# Access Compliance Report

## Public Rights-of-Way

Intersection ID: 15116	Main Street: EUCLID_AV	Cross Street: IDEAL_WY	Location: E
ADA ID: C9715974CDD8	Ramp Type: Directional1	Initial Pass/Fail: Fail	Overall Compliance: No
		Severity Score: 12.5

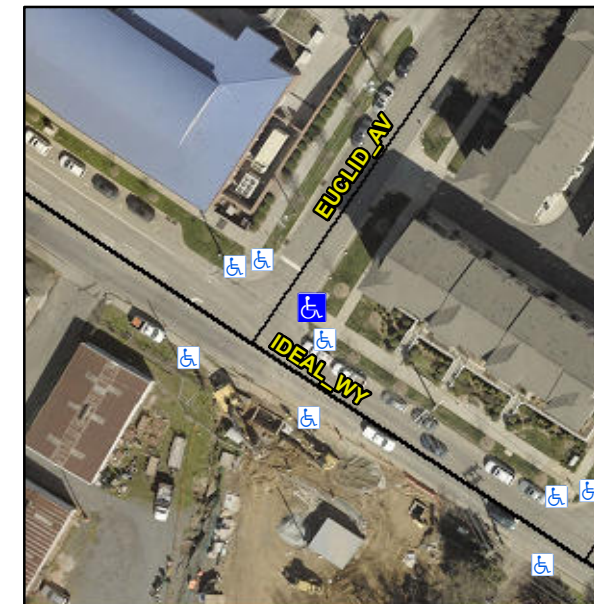
**Remove & Replace Entire Ramp.**

**R304.5.3**

Compliance	Description	Data	Compliance	Description	Data
N/A	Ramp Length (in)	96.0	N/A	Grade Break?	N/A
Yes	Ramp Width (in)	88.0	N/A	Grade Break Slope (%)	0.0
Yes	Ramp Slope (%)	6.1	N/A	Grade Break XSlope (%)	0.0
No	Ramp XSlope (%)	5.2			
N/A	Flare Type LT	N/A	N/A	Flare Type RT	N/A
N/A	Flare Slope LT (%)	N/A	N/A	Flare Slope RT (%)	0.0
N/A	Flare Traversable LT?	N/A	N/A	Flare Traversable RT?	N/A
N/A	Landing Length (in)	0.0	N/A	DWS Provided?	N/A
N/A	Landing Width (in)	0.0	N/A	DWS Contrast?	N/A
N/A	Landing Slope (%)	0.0	N/A	DWS Length (in)	N/A
N/A	Landing X Slope (%)	0.0	N/A	DWS Full Width?	N/A
N/A	Landing Curb? (Y/N)	N/A	N/A	DWS Offset LT (in)	N/A
N/A	Shared Landing?	N/A	N/A	DWS Offset RT (in)	N/A
N/A	Gutter Ponding?	0.0	N/A	Gutter Slope (%)	N/A
N/A	Gutter Lip Ht (in)	0.0	N/A	Gutter X Slope (%)	N/A
N/A	Painted X Walk1?	No		Road Slope (%)	4.3
	X Walk 1 Direction	To NW		Road X Slope (%)	7.1
	X Walk 1 Width (in)	N/A		Clear Space?	N/A
